Office Action Summary

10/758,567

This is the second office action for application number 10/758,567, Plate Stand, filed on January 14, 2004.

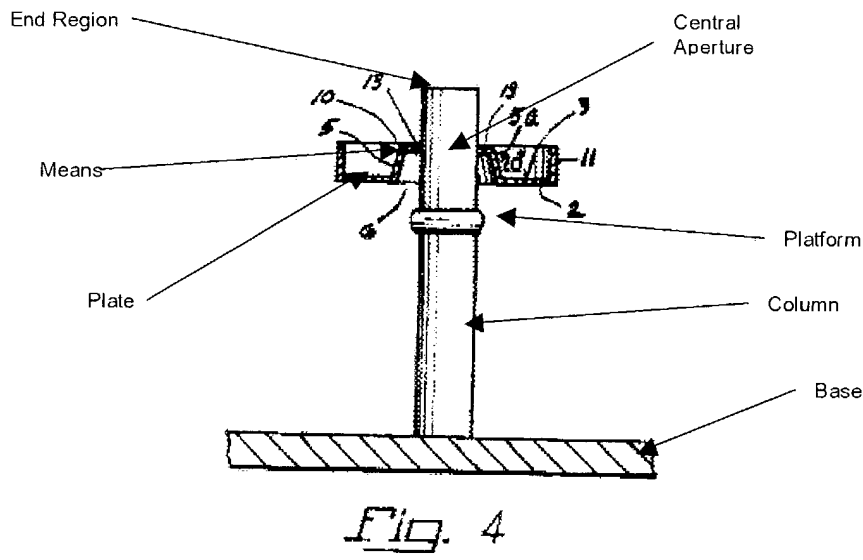
Claims 1, 2 and 7 are rejected under 35 U.S.C. 102(b) as being anticipated by U.S. Patent number 5,715,954 to Zaremba.

Zaremba '594 discloses a stand (above) comprising a support having an elevated holder comprising a platform (top surface of feature indicated above), a plate (above) held by the holder, and a means (above) for detachably mounting the plate on the holder, wherein the platform is above a base (above), and an upright column (above) extending between the base and the platform, wherein the plate has a central aperture (above), and wherein the column has an end region (above) which extends through the aperture.

FIG. 1

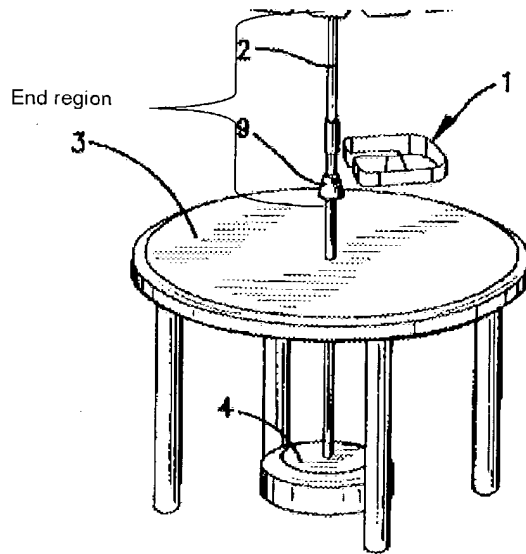
Claims 1, 2, 5, 7, 8, 9 and 18 are rejected under 35 U.S.C. 102(b) as being anticipated by U.S. Patent number 5,934,634 to Lindblom.

Lindblom '634 discloses a stand (above) comprising a support having an elevated holder (9), a plate (above) held by the holder, and a means (above) for detachably mounting the plate on the holder, wherein the support includes a platform (3) above a base (4), and an upright column (2) extending between the base and the platform, wherein the base has a planar bottom surface, wherein the plate has a central aperture (above), and wherein the column has an end region which extends through the aperture, wherein the mounting means is an element in engagement with the end region, where the element has a bowl-like shape, wherein the plate has a compartment.
